Subject: **Bid #: CR-8739-W7, Parking Lot Repairs – RECC / DPF**

ADDENDUM NO. 1

1 SITE PAVING PLAN
1/16" = 1'-0"

2 Concrete Pad @ Dumpster
1 1/2" = 1'-0"

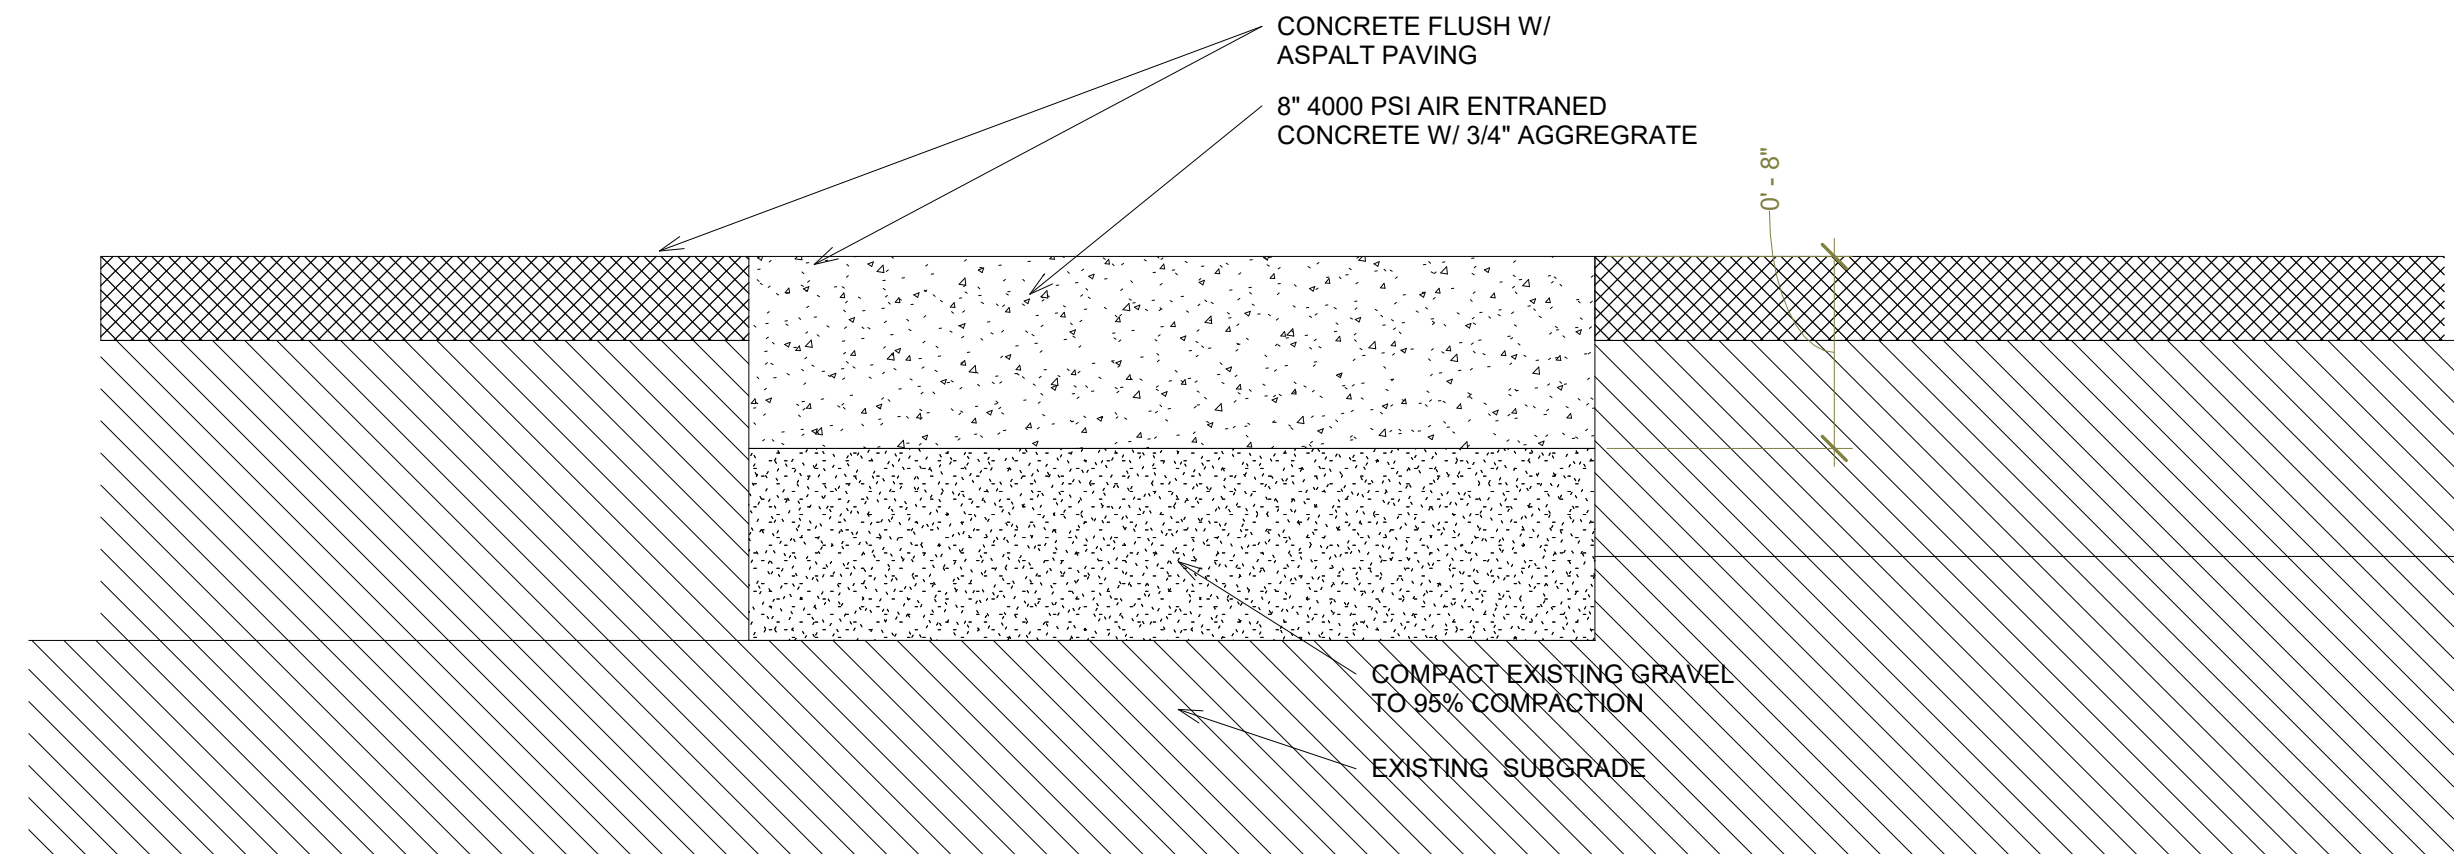
1. Increase Concrete Trash Truck Pad from 12' x 32' to 12' x 40'.
2. Provide 5 gallons of Attic Stock for asphalt crack sealer and sealant.

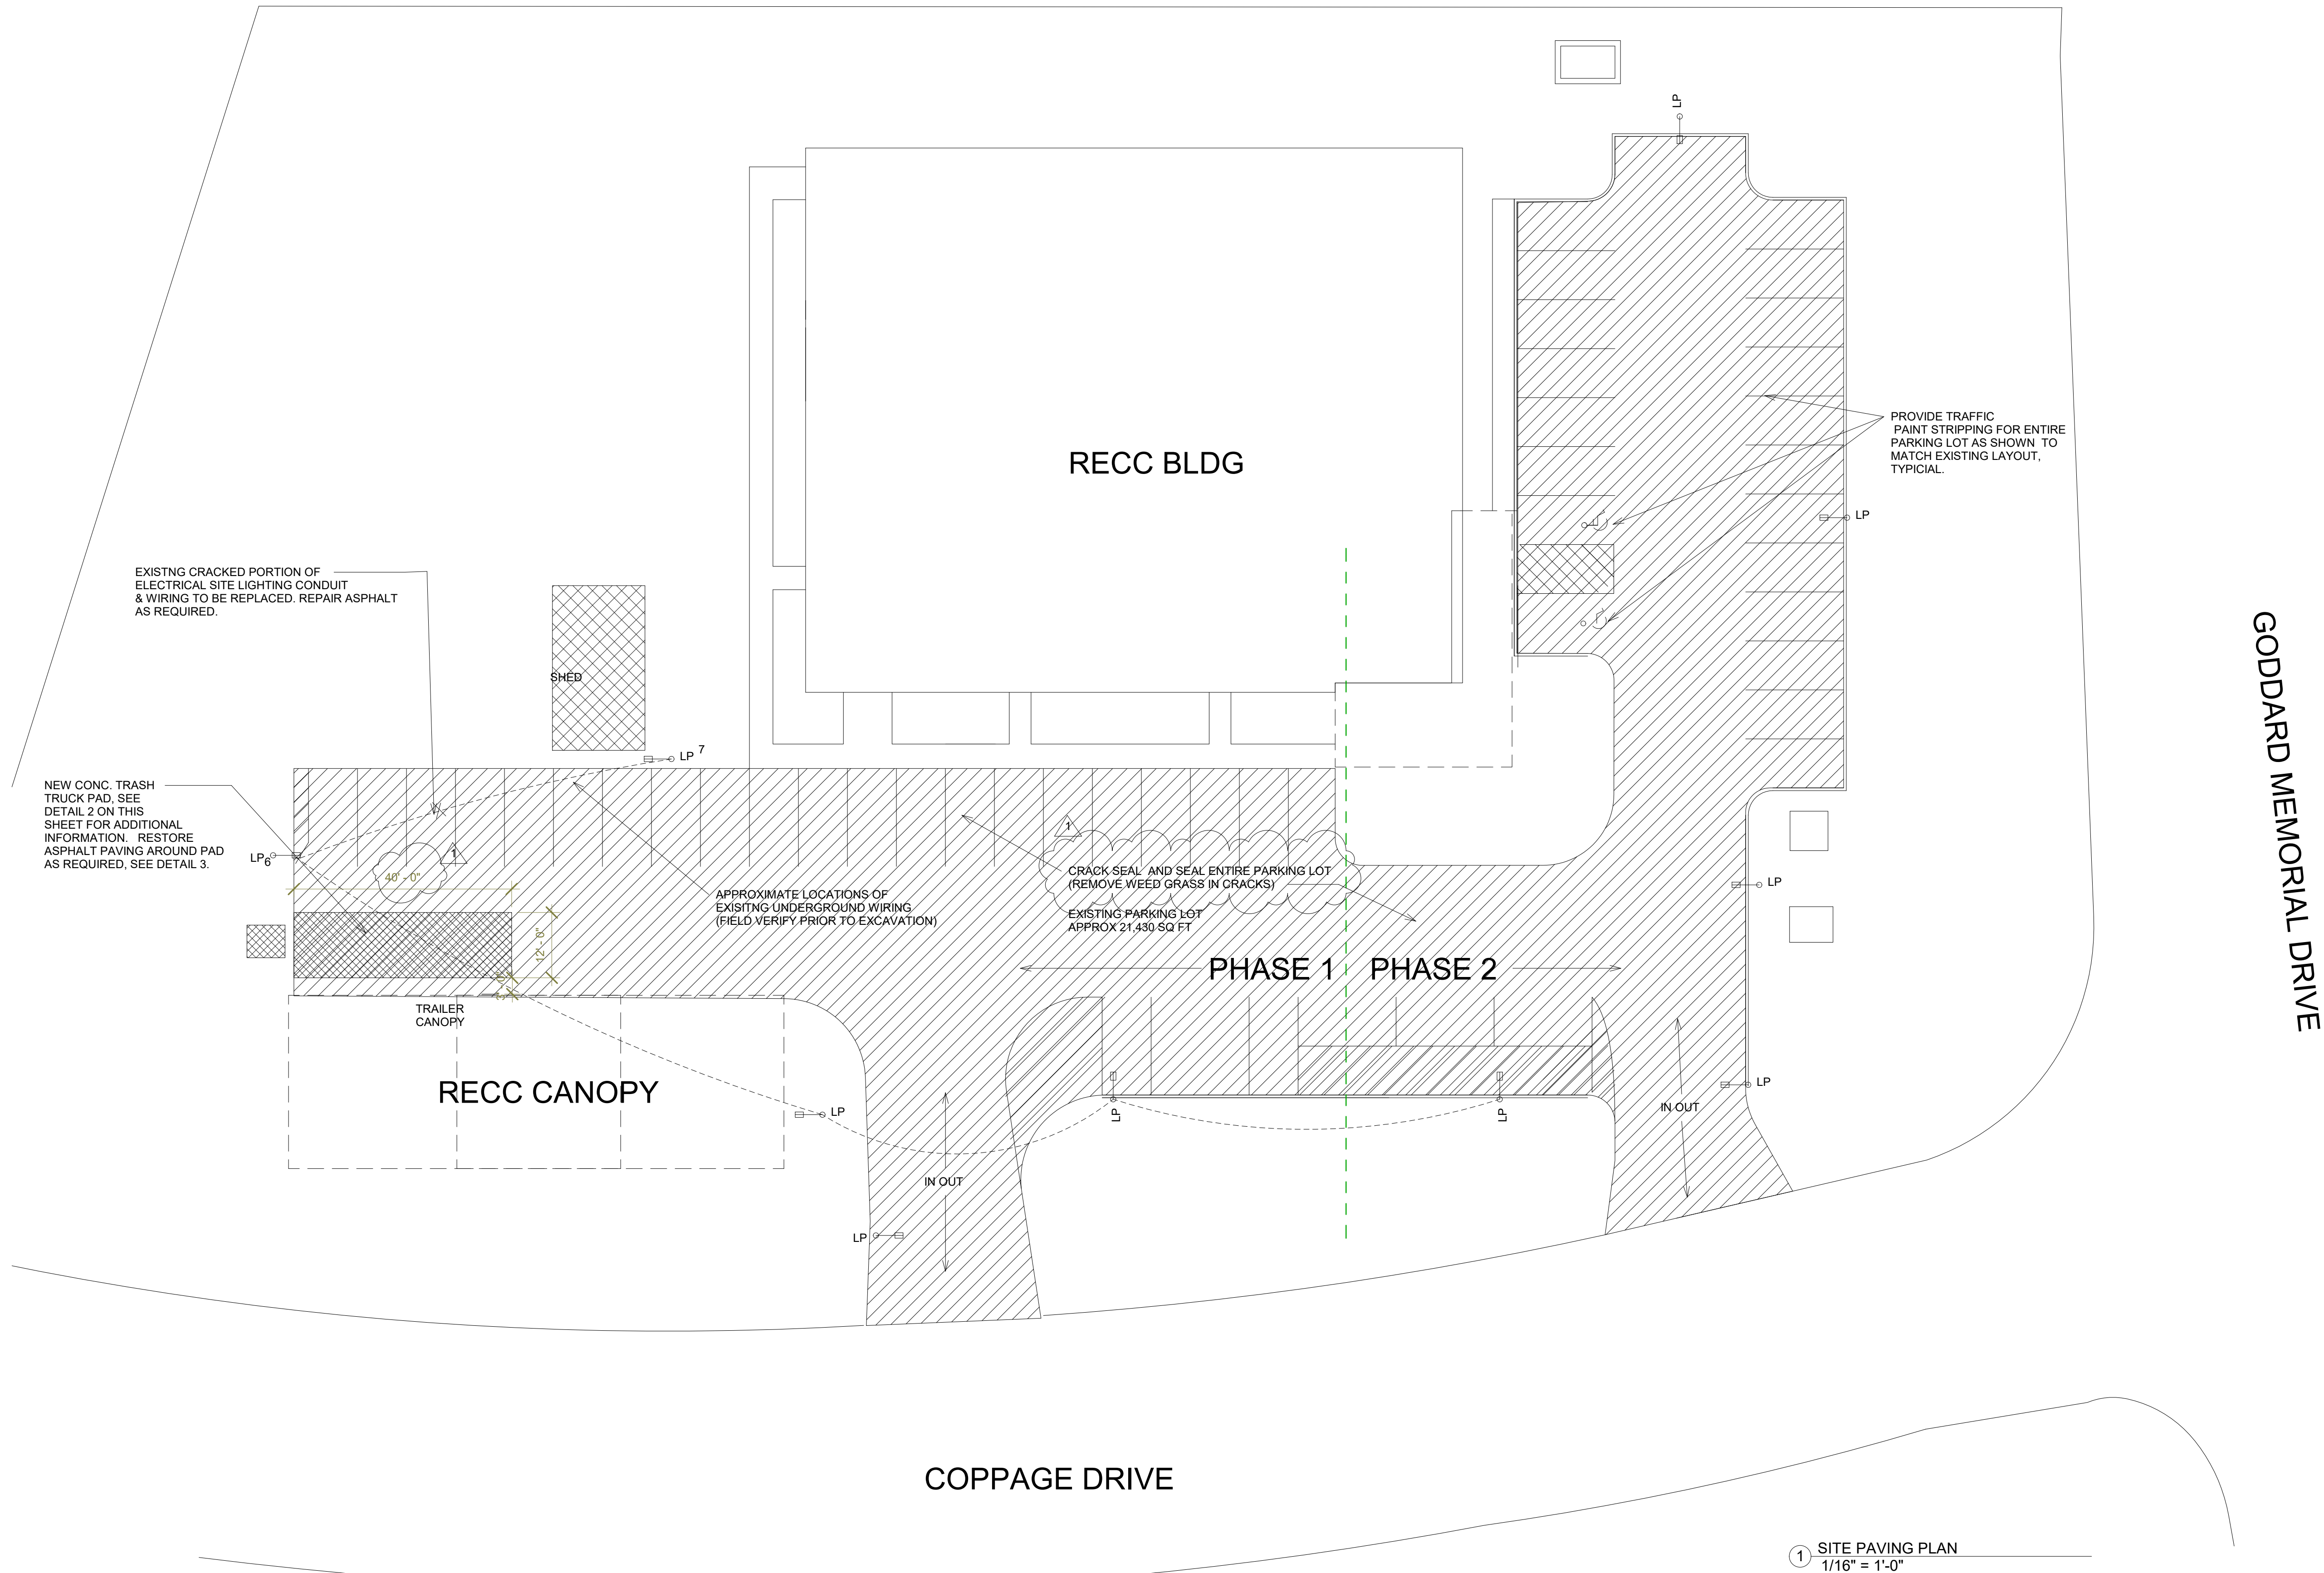
1. See updated existing underground conduit lighting layout to LP 7 at end of daisy chain wiring. Contractor to own replacement of existing wiring and conduits as required from LP 6 to LP 7.
2. Asphalt crack sealer, sealant and traffic are to be compatible with each other.
